Technical Service Bulletin: tsb100309

New Gear Cover Gasket

This purpose of This Technical Service Bulletin is to inform the field of an improvement made to the gear cover gasket used on QSK45 and QSK60 engines. The new gasket was introduced to improve sealing capability around the oil drilling orifices.

Figure 1 New Gear Cover Gasket, Part No. 4100983.

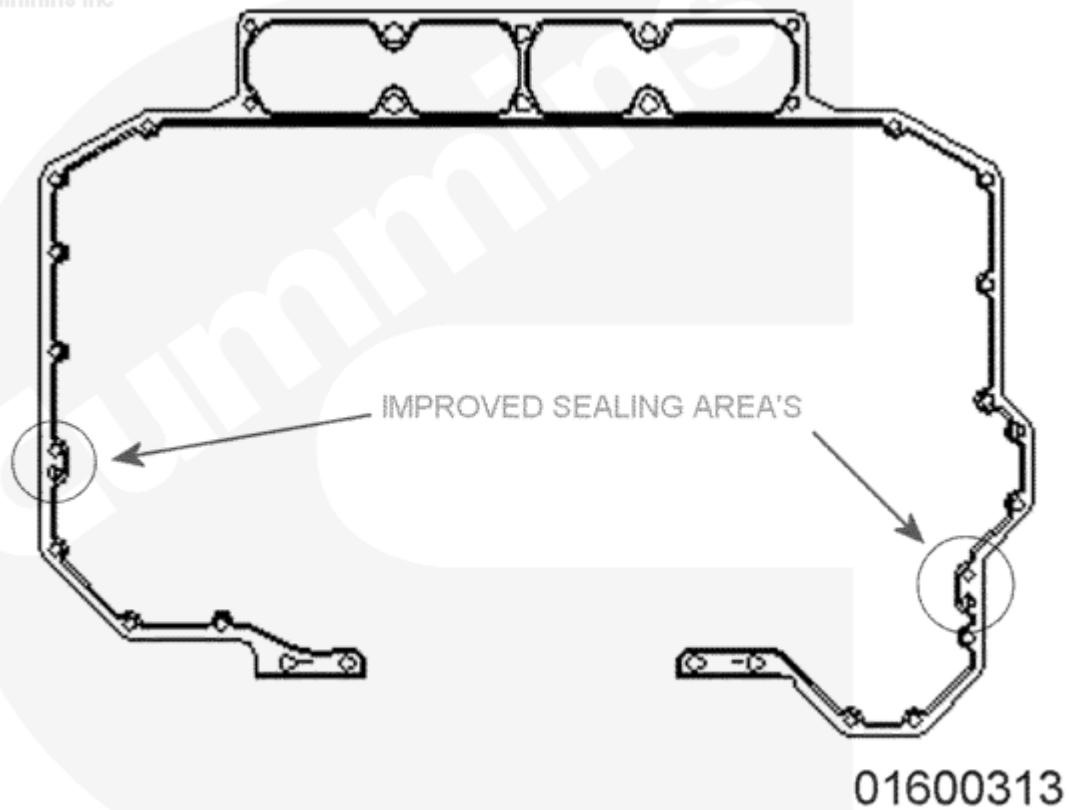
The old gear cover gasket, Part No. 3332035 was obsoleted and superseded by new gear cover gasket, Part No. 4100983.

The new gear cover gasket was released April 2003 , with Engine Serial Number first of 33153813.
